July 24, 2020

RE: Site Review of CP 414 blocks 1 and 3 and proposed roads in the Deception/Deep Creek Area.

Figure 1

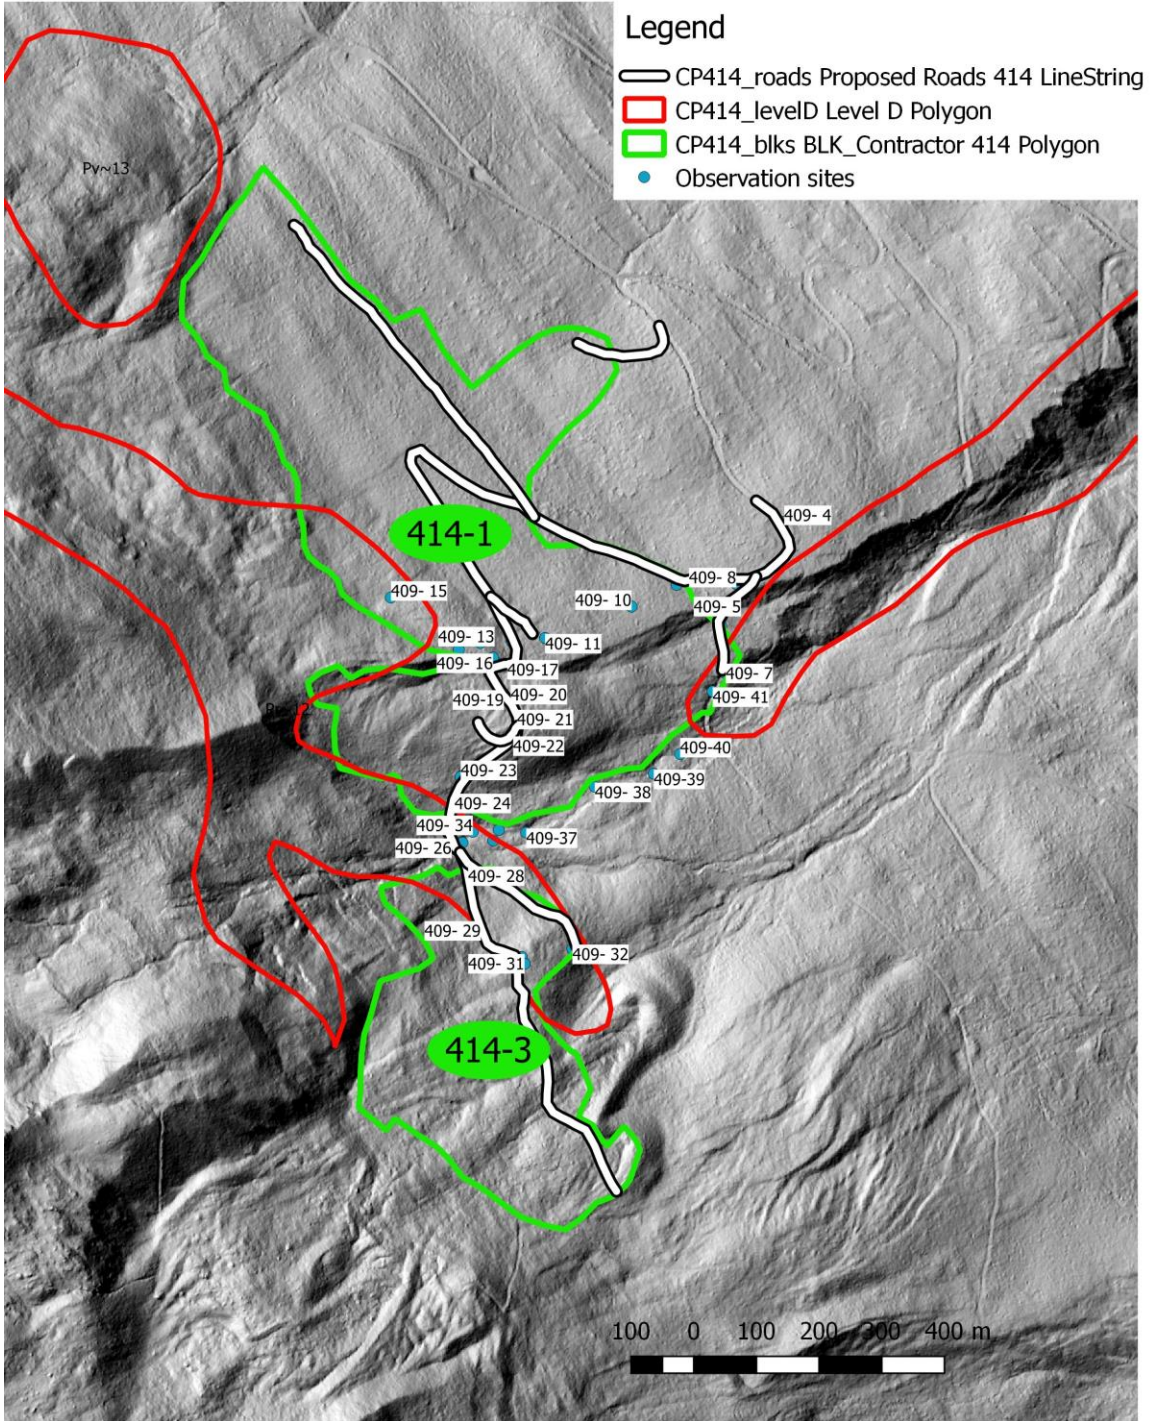
Both the blocks and roads are underlain by ancient glacial features. Much of the area appears to have been a "Rock Glacier". The portions of the blocks and road that are within the P polygons were traversed and inspected for instability. The stream that flows out of the Block 1 and crossed by the road was traversed and reviewed for sensitivity to altered flood frequencies and any evidence of past debris flows.

No evidence of instability was noted within the proposed blocks or within the stream. One small section of the proposed road crosses a short steep slope (station 409-17), it is likely that the actual road location will not traverse this slope for any length.

A DTSA is not required for the proposed blocks or roads.
